Planning Commission
Meeting Date: March 2, 2016

FILE NUMBER/
PROJECT NAME: CUP-16-002 Canyon Centre Phase III
LOCATION: 7350 S Wasatch Boulevard
REQUEST: Approval of Conditional Use Permit for phase III site plan approval for a restaurant approximately 4,800 s.f. in size on 0.78 acres.
OWNER: Canyon Centre Capital LLC – 801-984-5770
ARCHITECT/
DESIGNER: Think Architecture – Kenney Nichols – 801-269-0055
APPLICANT: Think Architecture – Kenney Nichols – 801-269-0055
RECOMMENDATION: APPROVAL subject to conditions of approval

PHASE III LANDSCAPING / SITE PLAN

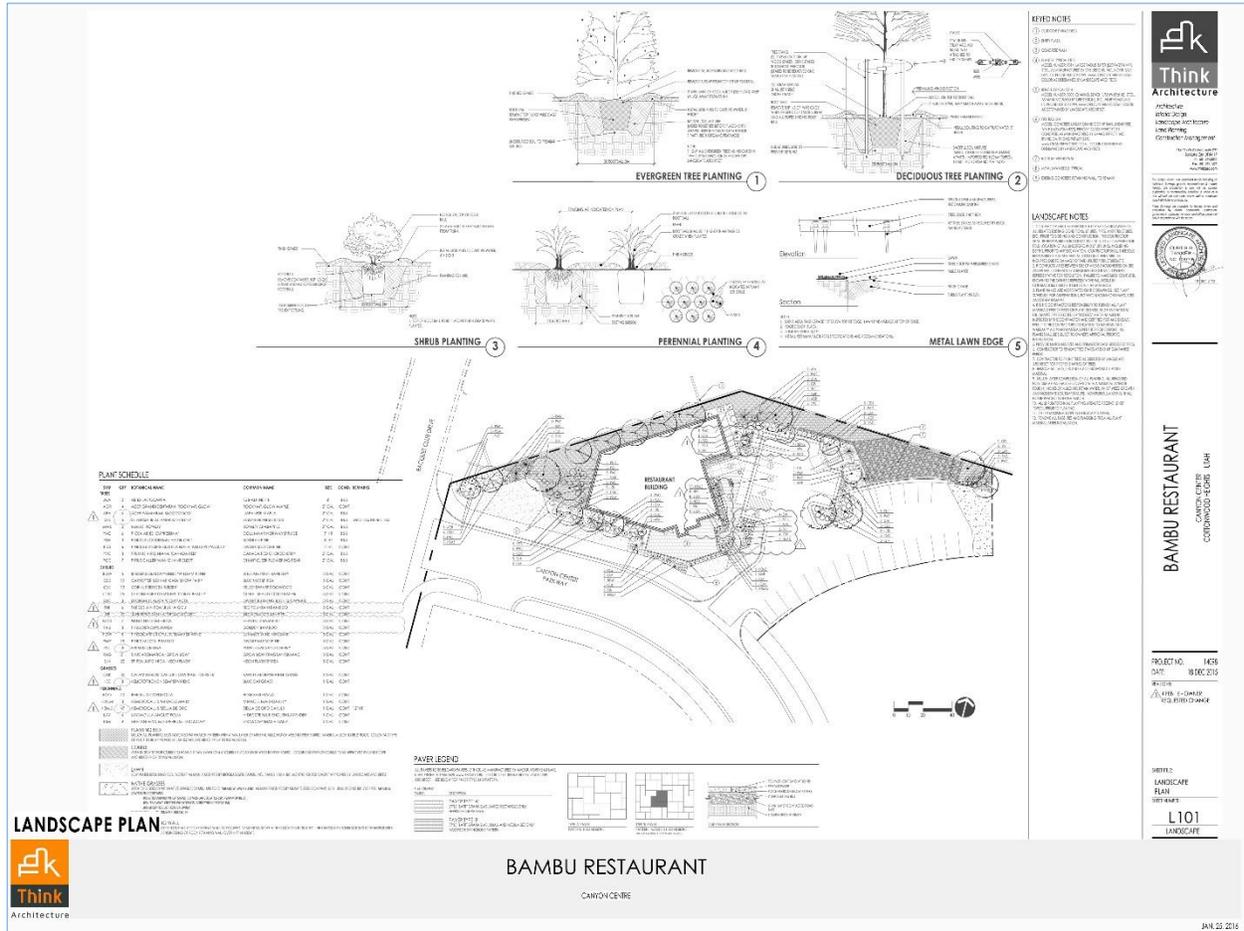
1. Planning Set is incomplete and a full construction plan set must be submitted for city review.
 2. Plans must include a site plan showing all existing features on site. Include existing concrete wall and any other existing features.

4. Proposed roadway improvements including ADA ramps, Curb & Gutter, sidewalk, fencing, and all other improvements must be labelled. Include detail sheets for all proposed improvements.

5. An ADA Ramp at Racquet Club Drive and Canyon Centre Intersection must be included.
 6. Detailed elevation data including RIM/INV elevation for all proposed storm drain facilities must be provided.

7. Size of proposed inlets boxes and reference details must be labelled.
 8. Tie-in elevations for all curb & gutter matching the existing TBC must be shown.

9. ADA ramps and detectable warnings at all proposed intersections must be labelled.
 10. Construction details for all proposed improvements, including, sidewalk, ADA Ramps, driveways, street lights, landscaping, storm drain improvements, and all other improvements must be submitted. All proposed improvements must meet APWA 2012 standards.

11. All on-site parking lot striping and drive approaches must be labelled.
 12. A 2 % grade away from all proposed building in all directions must be maintained.
